RECOMMENDATION MEETING
ADMINISTRATIVE DESIGN REVIEW

SDCI
3032555-LU
3032666-LU
3032663-LU
3032664-LU
2020 - 2106 NE 85th Street
Seattle, WA 98115

85TH ROWHOUSES AND TOWNHOUSES

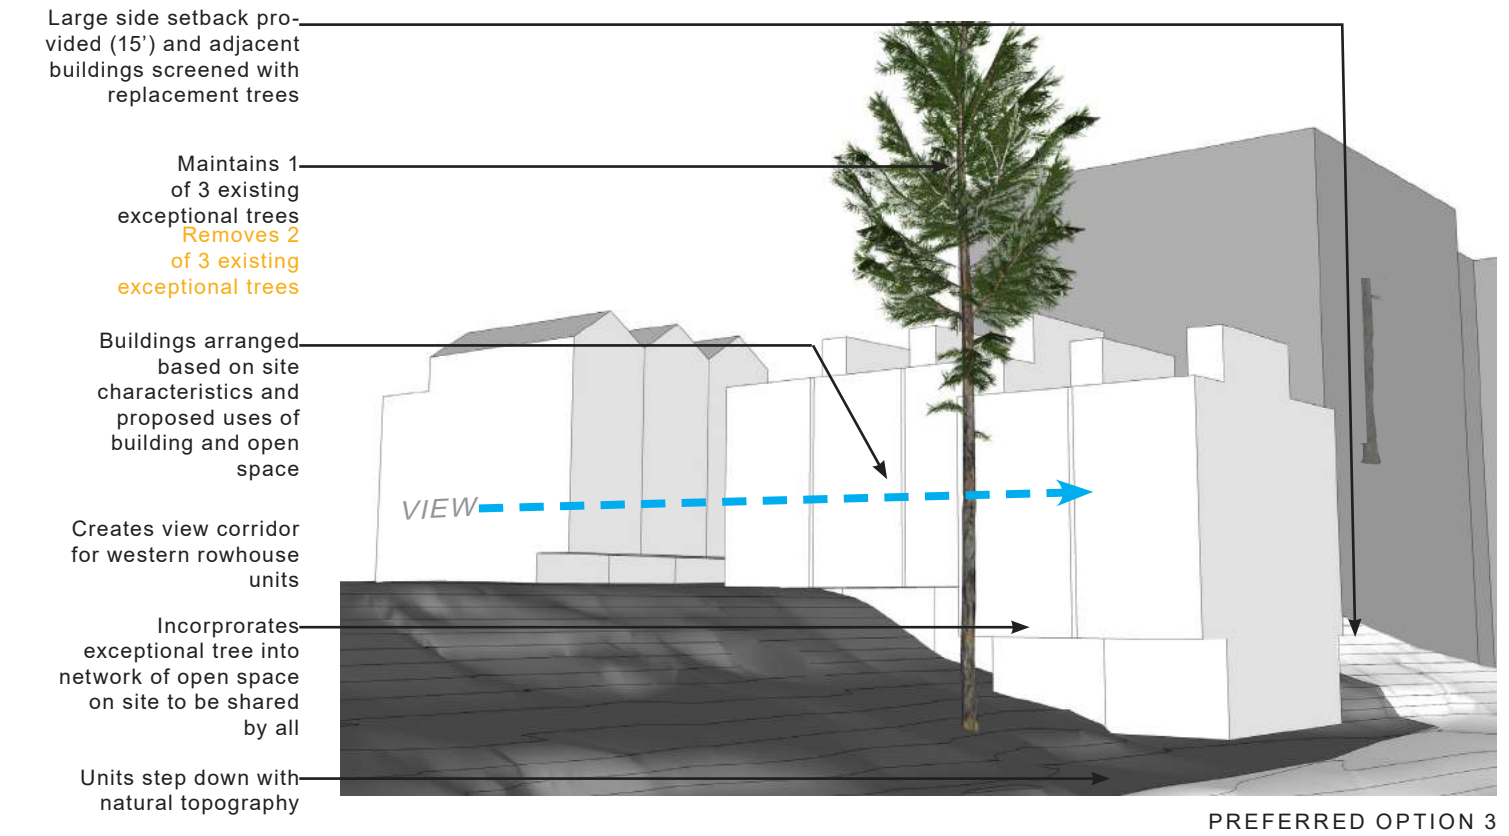
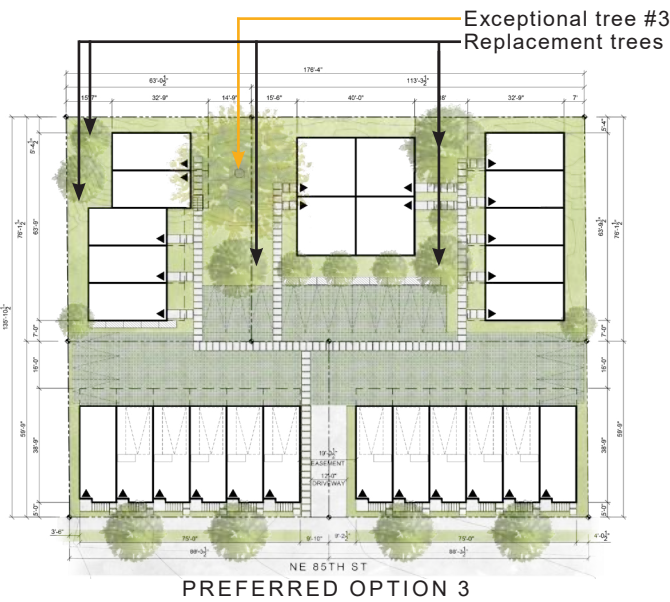
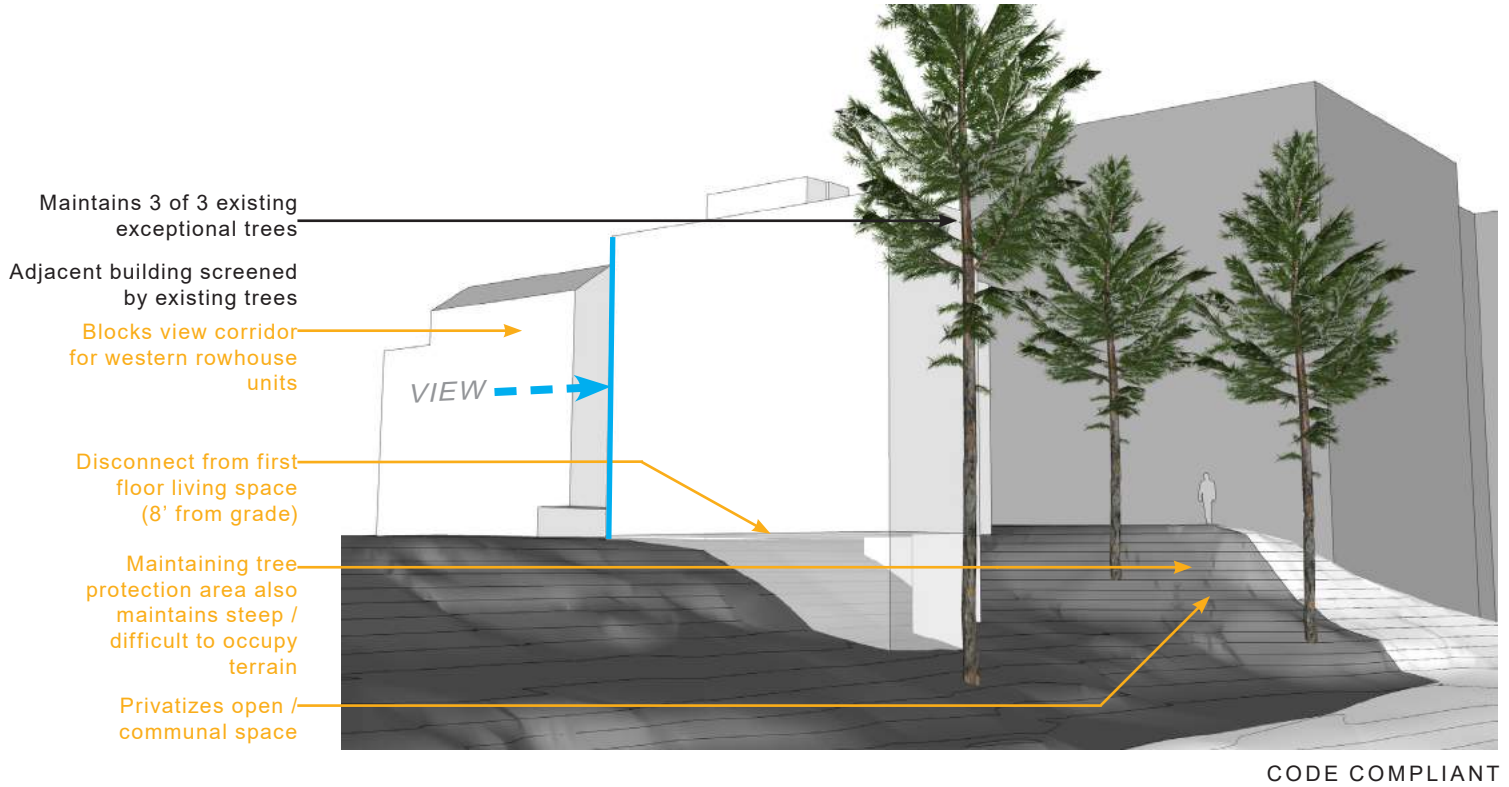
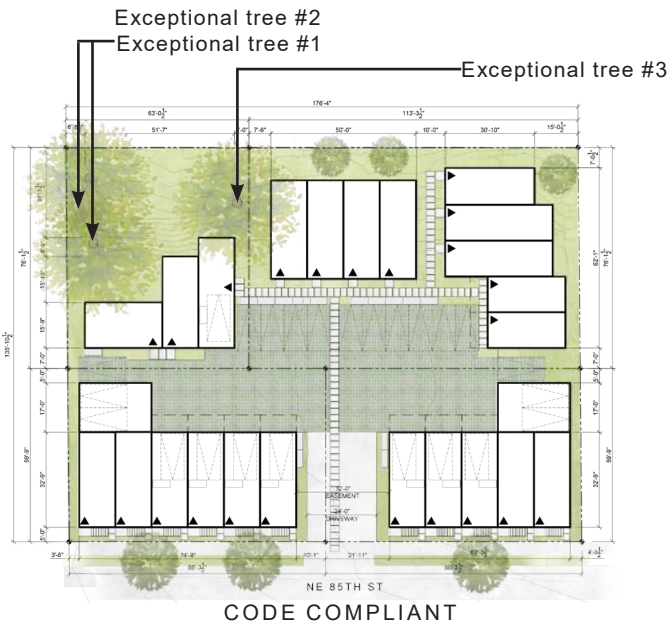
1. MASSING:
Staff supports the applicant’s preferred massing scheme, option 3. The rowhouse massing at the street with pitched roofs continues the pattern established by the adjacent new development to the west and is appropriate for the single-family context that begins across the street to the south. The arrangement of the townhouses at the rear of the site fosters a sense of community by orienting the units around shared open space. However, this massing scheme fails to protect two of the three existing exceptional trees on site. Mitigation of this loss is necessary to respond to design guidelines and is further described below under the open space section. (CS1-c, CS3-a-1, DC3-b-4)

APPLICANT RESPONSE:
Thank you for supporting our preferred scheme. The diagrams on this page and the next were shared with SDCI staff after EDG as supplemental context to further justify the removal of the other two exceptional trees. Please see pages 25 and 26 for responses to items 3b and 3c.

COMPOSITE LANDSCAPE PLAN

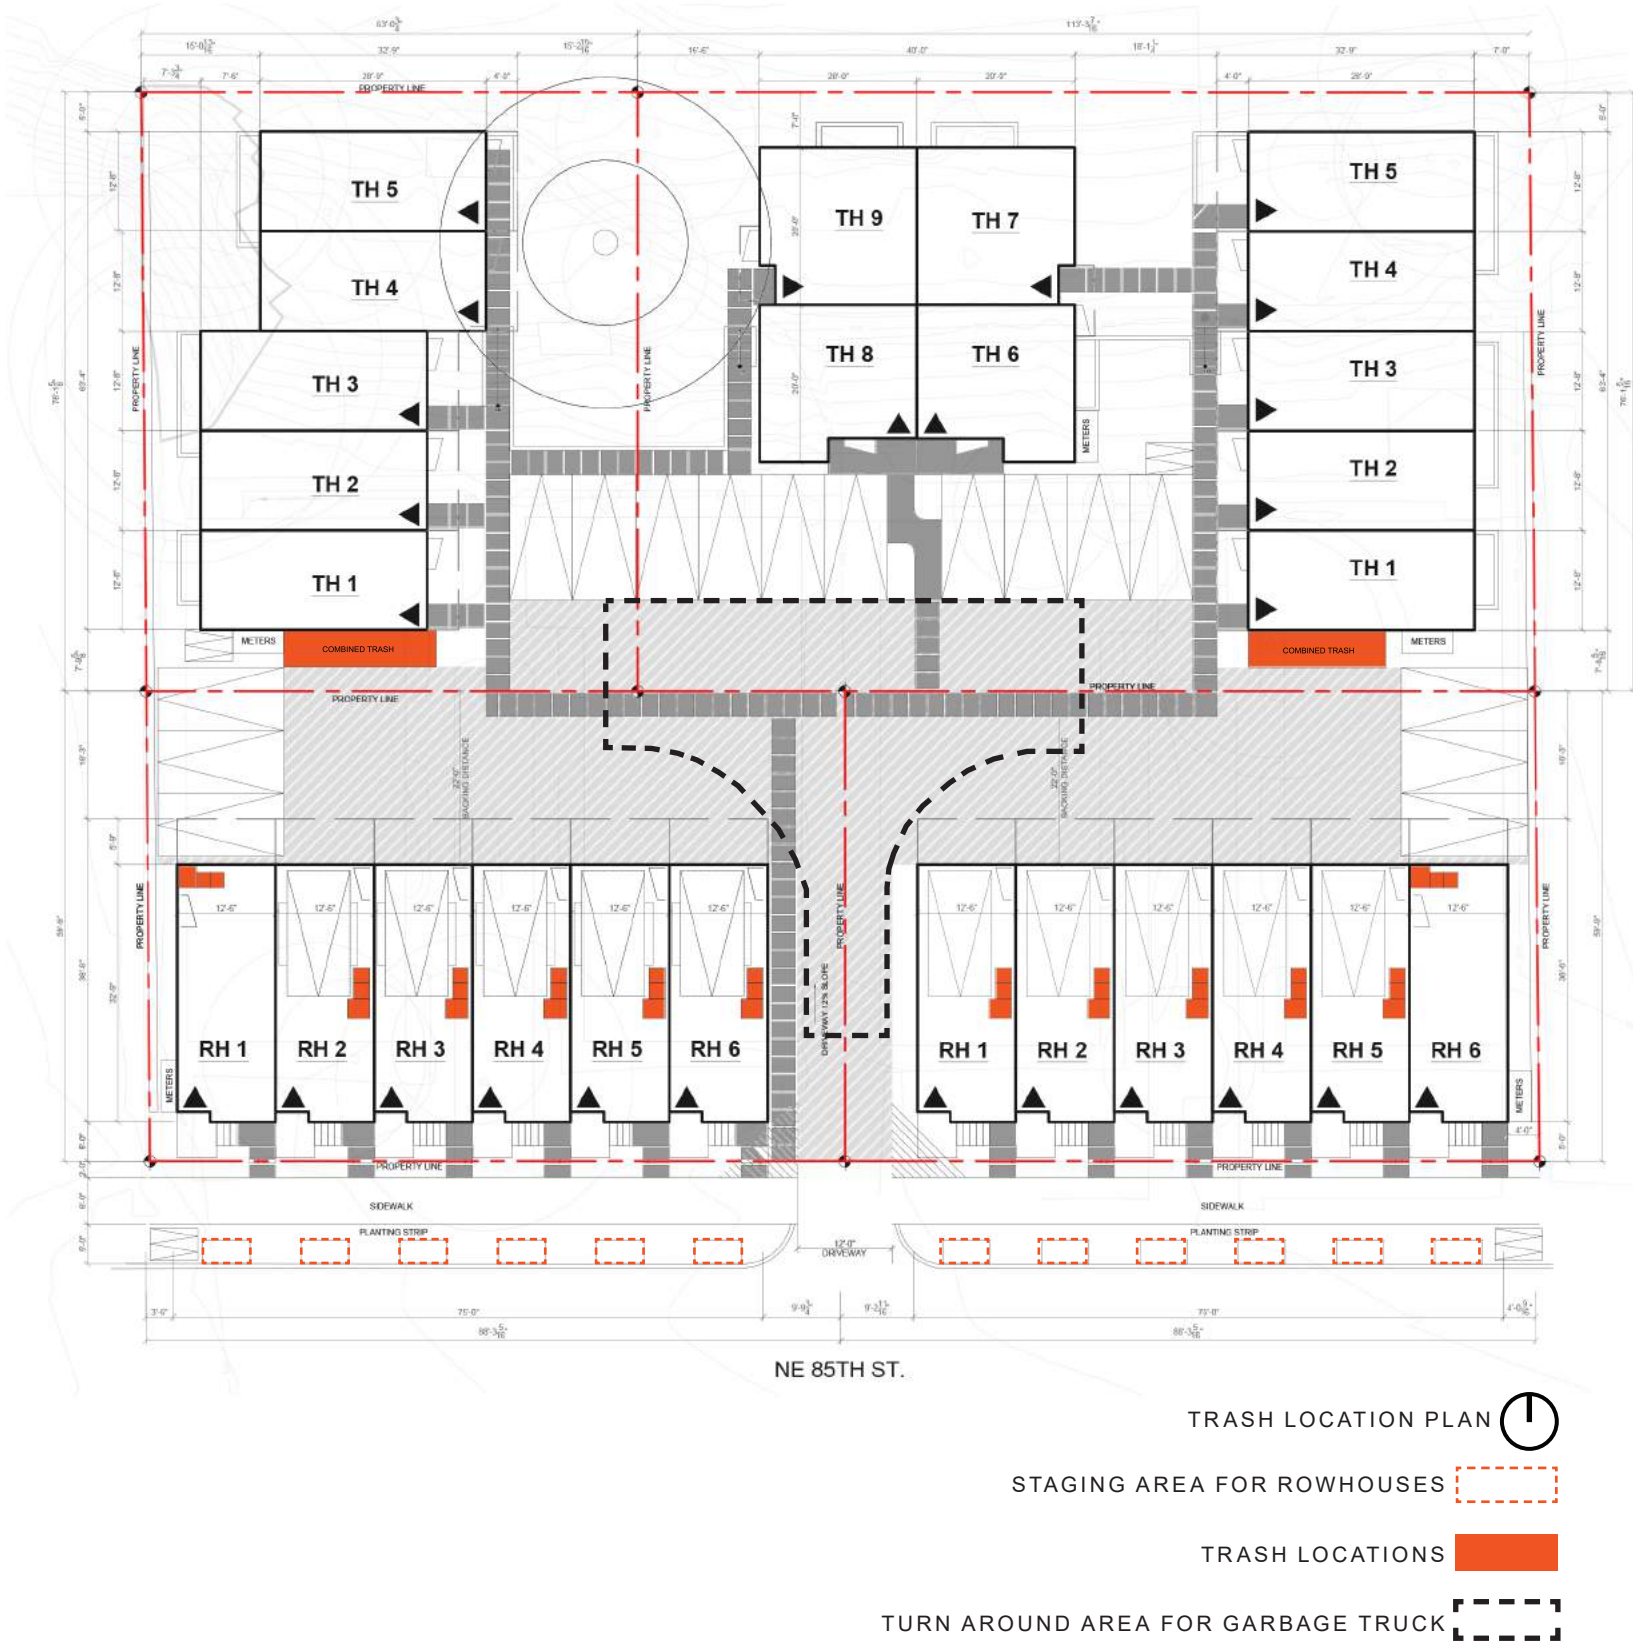
C. Mitigation for the loss of two exceptional trees will need to be integrated into the MUP plan set and should include replacement trees of substantial size (36" box or larger at time of planting. Select species that will reach similar heights at maturity to those that are proposed for removal so that the aesthetic benefits to the community are restored over time (DC4-d)

Please see combined landscape plan to the right for the locations. Species and replacement calculations can be found in the landscape plans in the MUP sets for each parcel.

OVERALL DEVELOPMENT
DESIGN STANDARD
SMC 23.53.025.D
ACCESS EASEMENT STANDARDS

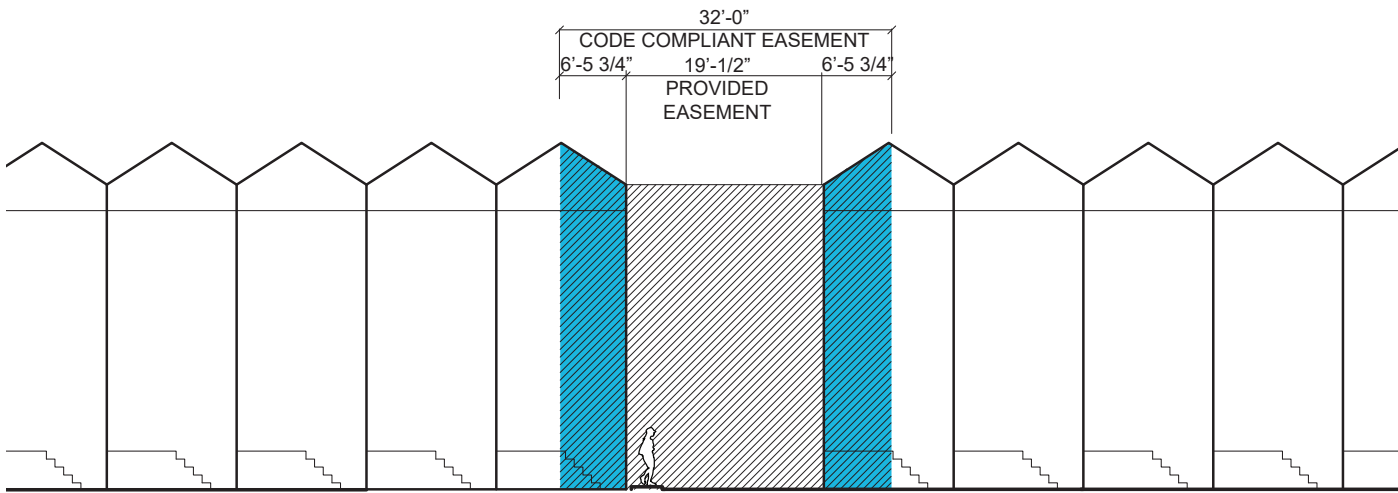
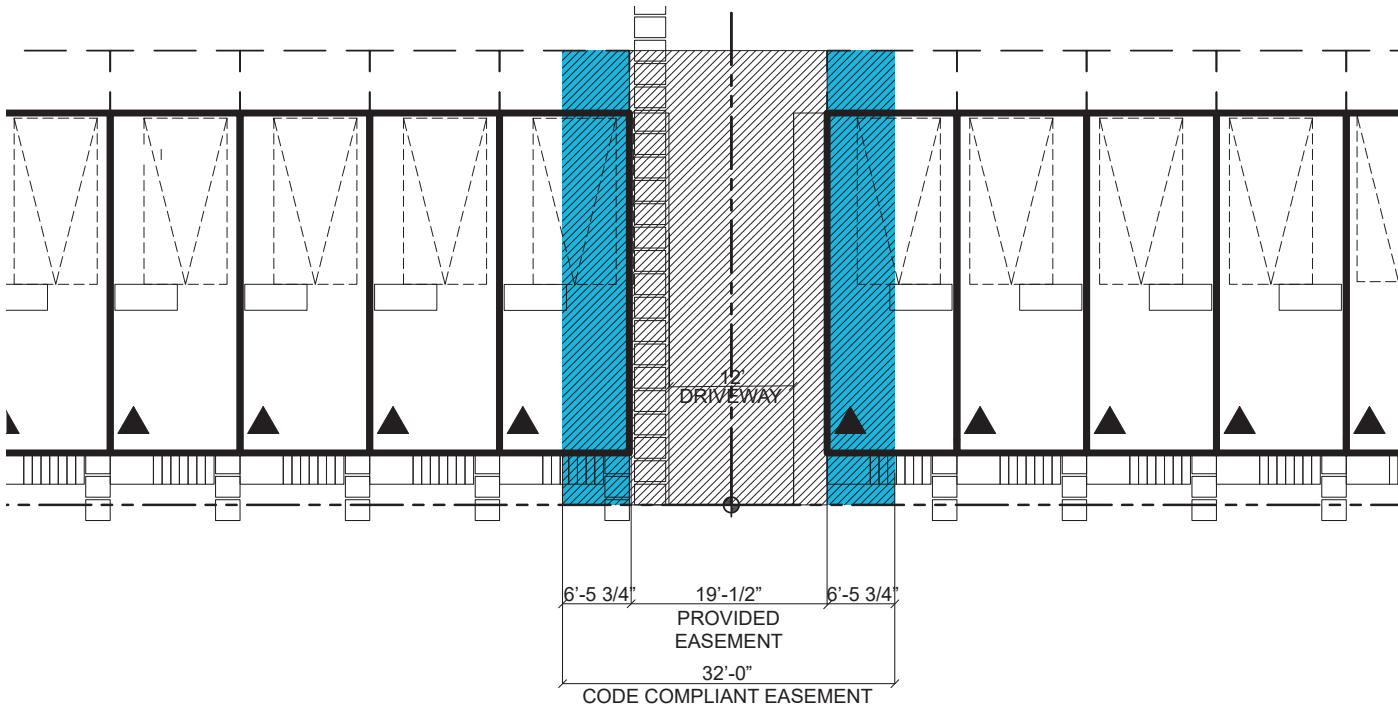
CODE REQUIREMENT:
Vehicle Access Easements Serving Ten or more Residential Units. Easement width shall be a minimum of 32 feet; The easement shall provide a surfaced roadway of at least 24 feet wide...

PLANNER'S RESPONSE:
Vehicle access easement standards (SMC 23.53.025.D): The code requires an access easement with a minimum width of 32 feet and a surfaced roadway of at least 24 feet in width. The applicant proposes an easement measuring 19 feet in width and a 12 foot wide surfaced roadway. Staff notes that the reduced driveway width helps to reduce the dominance of vehicle-related uses on the streetscape. However, traffic impacts will need to be studied further to determine if safety and traffic concerns are present and outweigh this benefit. Staff is supportive of the requested departure, pending the findings and recommendations of the SEPA review with the master use permit.

PARCELS A & B
DESIGN STANDARD
SMC 23.45.518.H
PROJECTIONS PERMITTED IN REQUIRED SETBACKS

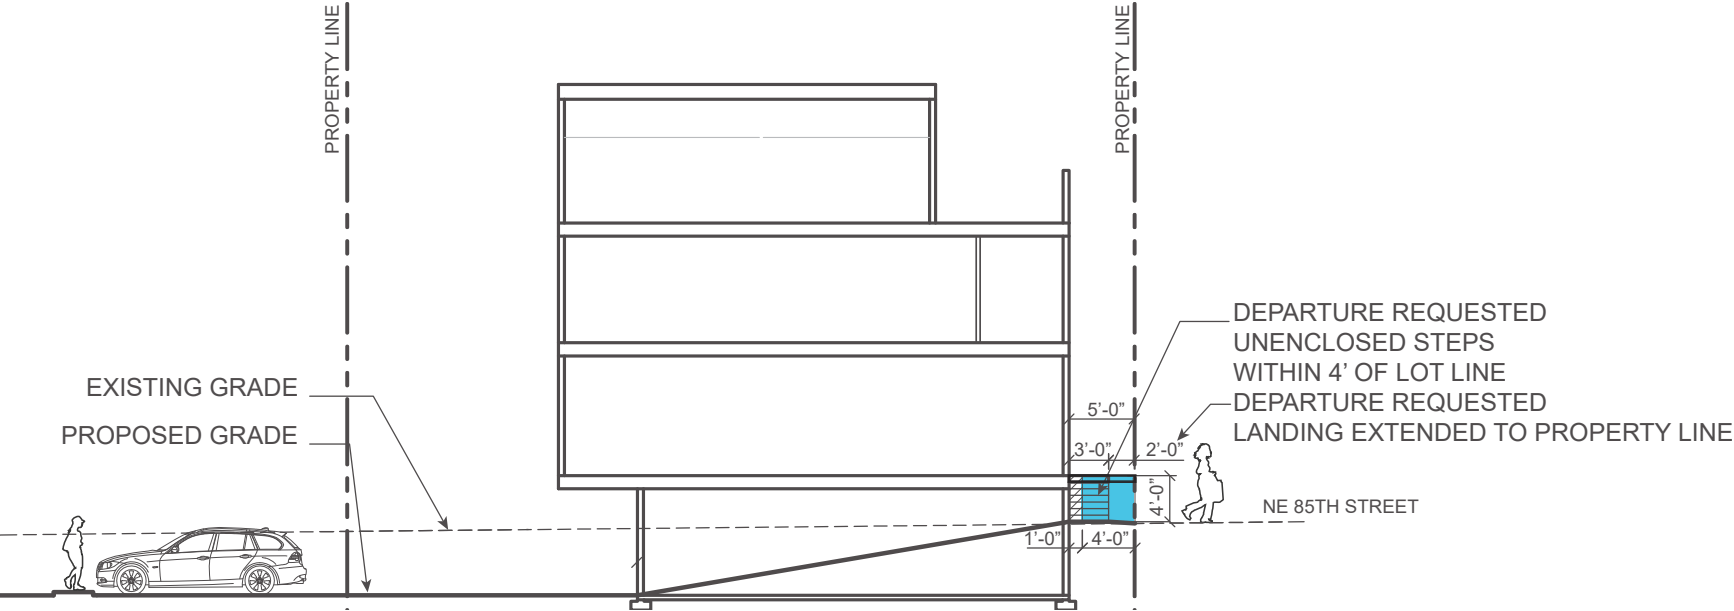
DEPARTURE REQUEST:
To allow for unenclosed steps 3’-6” high to be within 2’ of the street lot line and the extension of the landing to extend to the street lot line.

RATIONALE FOR DEPARTURE:
The rowhouses on this project seek to provide a stoop up to each entry as a transitional element between public and private space. The extension of the landing ensures that the space is both usable/functional as well as more engaged with the street and public realm. This helps the proposed units to better fit with the design guidelines as well as the surrounding neighborhood. The code limits how close stairs can be to the property line- the addition of these stairs/stoops would help add to the collection of elements at each entry, enhancing the pedestrian experience and providing opportunity for personalization.
Design Guideline: DC2.B.1

PLANNER’S RESPONSE:
Projections permitted in required setbacks (SMC 23.45.518.H): The code limits the location of unenclosed steps to no closer than four feet from a street lot line. The applicant proposes unenclosed steps within two feet of the street lot line. The raised entries provide an opportunity for additional connection to the public realm and a small amenity area that can be used by residents. These added benefits contribute positively to the streetscape, but are not fully realized in the current proposal. Landings should be extended to provide space for planters and/or small furniture, allowing for personalization and increased engagement with the public realm. Staff is supportive of the proposed departure, dependent on the design being further developed to accommodate more activity and engagement with the street.
